### **SCHEMATIC DIAGRAM**

## **VIDEO TECHNICAL BULLETIN**

<b>MODELS</b>	VCM26HM	VCM27HM	VCMH67HM
	VCMH68HM

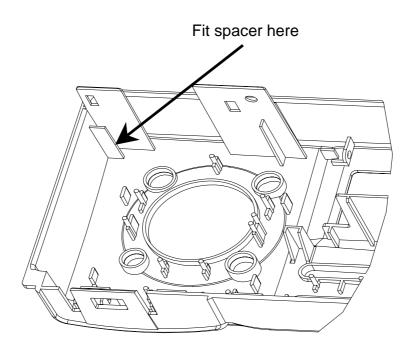
**SYMPTOM** The operation of the tape control buttons on the front panel, particually the fast

forward and rewind buttons, under certain conditions, become sensitive and operate

by slight pressure on the top of the front cabinet.

**CAUSE** A degree of warpage may be present in the front panel which will alter the position of

the play button assembley in relation to the switches on the main PWB. This will then

increase the sensitivity of the button operation.

**ACTION** Fit a 25.0 x 9.0 x 0.5mm spacer as indicated in the diagram below.

Relationship Between the Head Switching Point and the Video Output Waveform

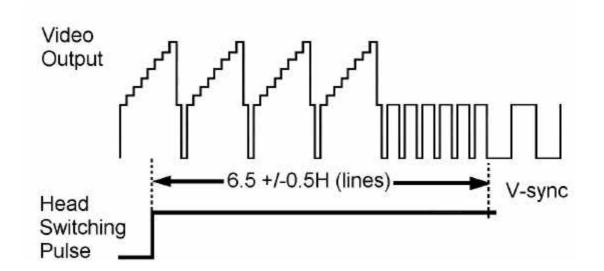
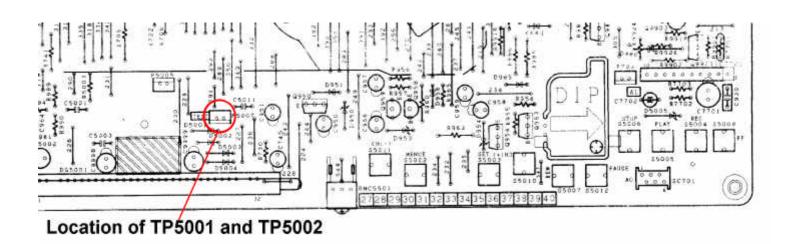
**SYMPTOM** Head switching point requires adjustment.

When carrying out the head switching adjustment for any of the above models, follow the procedure outlined below.

- 1. Remove the front panel so that access can be gained to the test mode pins.
- 2. Insert the alignment tape (VROCPSV) into the machine.
- 3. Play back the alignment tape.
- 4. Make a momentary short circuit between test points TP5001 and TP5002 (see diagram on page 2).
- 5. Press the PLAY button the automatic adjustment is completed at this point (the play symbol may flash during this process).
- 6. Press the STOP button to return to the normal mode.

Correct head switching points can be checked by connecting an oscilloscope to the video output and triggering it off the head switching pulse (TP2202). Note that if the head switching points can be monitored during the automatic setting procedure.

Holder one

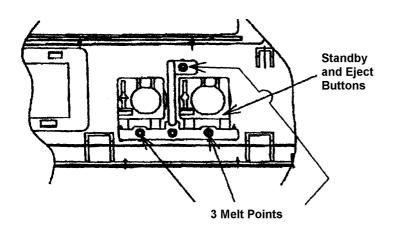
**SYMPTOM** Failure of the front panel buttons.

**CAUSE** Excess travel of the button, causing the hinge to fracture.

**ACTION** Replace the broken button assemby and add the holder as shown in the following

diagrams.

Note that there are two types of holder for different models.

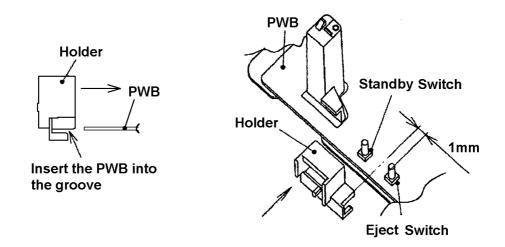
2b. Melt the Standby and Eject button into position for Holder Two models (note that there are two one melt point)

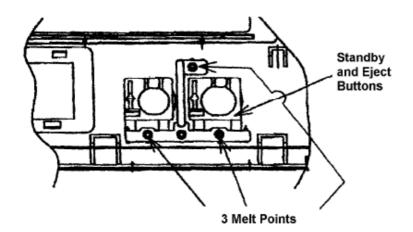
**SYMPTOM** Failure of the front panel buttons.

**CAUSE** Excessive travel of the button, causing the hinge to fracture.

**ACTION** Replace the broken button assembly and add the holder as shown in the following

diagrams.

Note that there are two types of holder for different models.

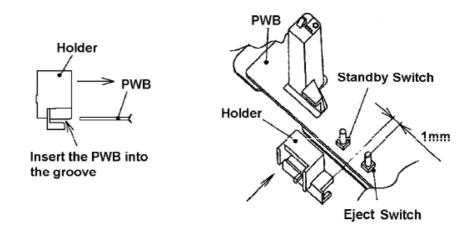
2b. Melt the Standby and Eject button into position for Holder Two models (note that there are two one melt point)
